# MANDATORY SERVICE BULLETIN

## NO. MSB-D4-064

Installation of a high flexible alternator cable.

WI-MSB-D4-064

Figure 1

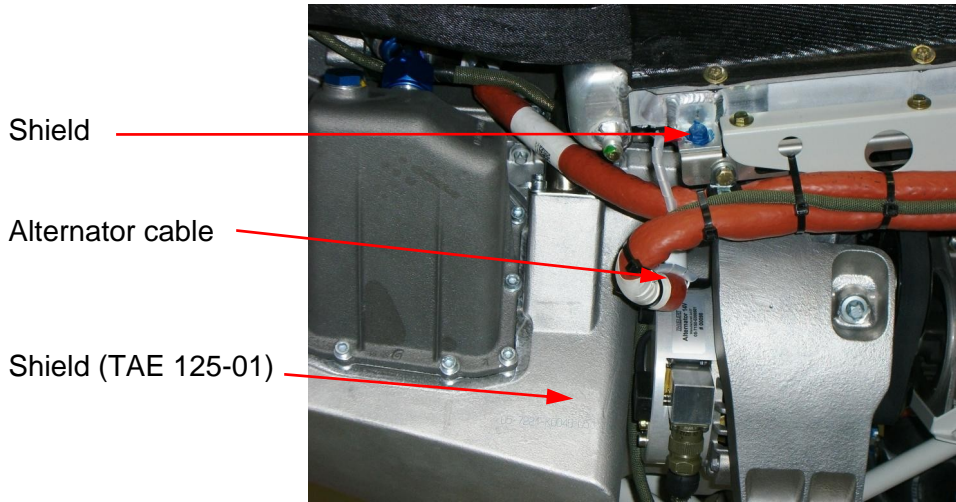
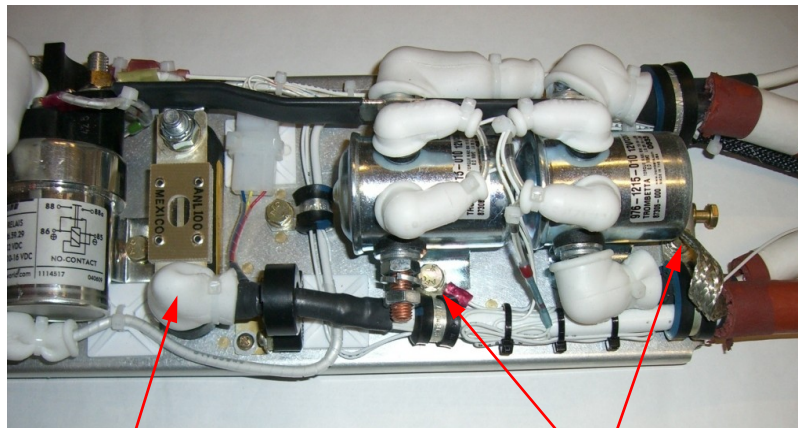
- 6 Disconnect alternator cable and the shield drain at the alternator as shown in the figure below.  
**NOTE:** The figure shows a TAE 125-02-99 engine installation, whereby the shield is connected to a different point, compared to the TAE 125-01.

Figure 3

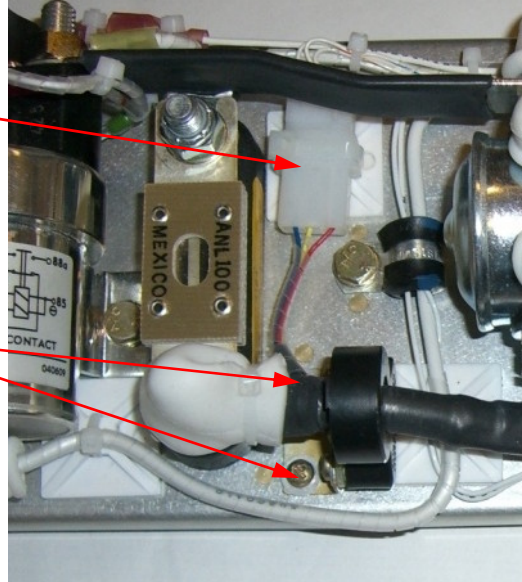
8 Disconnect the current sensor at the inline connector and remove sensor assembly as shown in the figure below. If necessary, cut the cable tie.

Figure 4

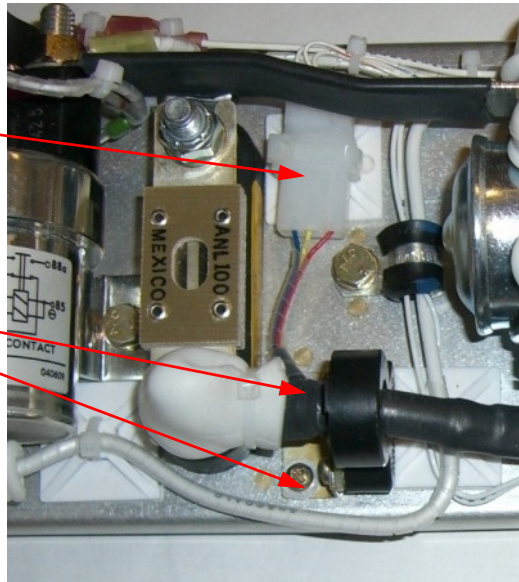
11 Connect the current sensor assembly at the inline connector and install sensor assembly into its position as shown in the figure below.

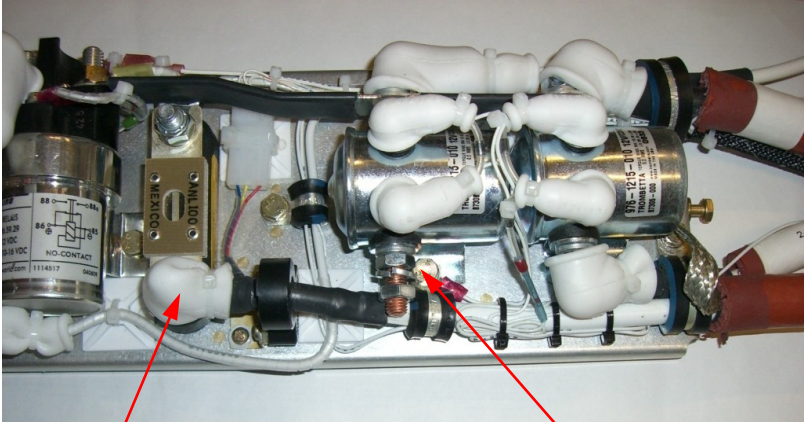
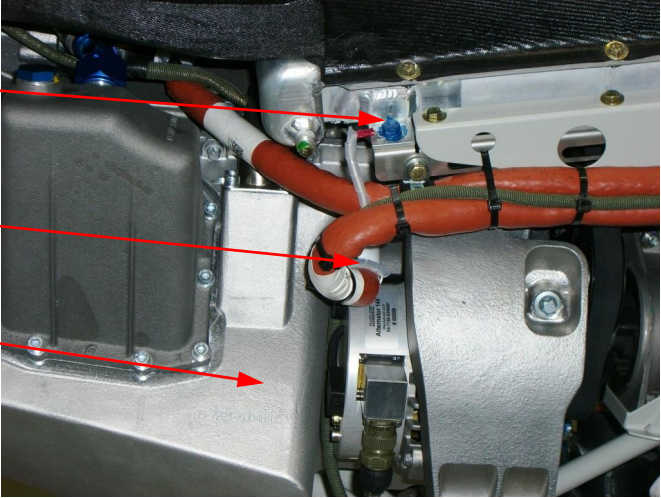
12	<p>Connect the alternator cable and the shield drain in the relay junction box as shown in the figure below and install the cable clamps if prior removed.</p>  <p style="text-align: center;">Figure 5</p> <p>Alternator cable                      Shield</p>
13	<p>Connect the alternator cable and the shield drain at the alternator as shown in the figure below.</p> <p><b>NOTE:</b> The figure shows a TAE 125-02-99 engine installation, whereby the shield is connected to a different point, compared to the TAE 125-01.</p>  <p style="text-align: center;">Figure 6</p>
14	Install the cover of the relay junction box.
15	If removed, install the coolant radiator in accordance with the AMM.
16	Clean working area and check for foreign objects.
17	Connect the alternator excitation battery in accordance with the AMM.
18	Connect the ECU backup battery, in accordance with the AMM.
19	Connect the airplane main battery, in accordance with the AMM.
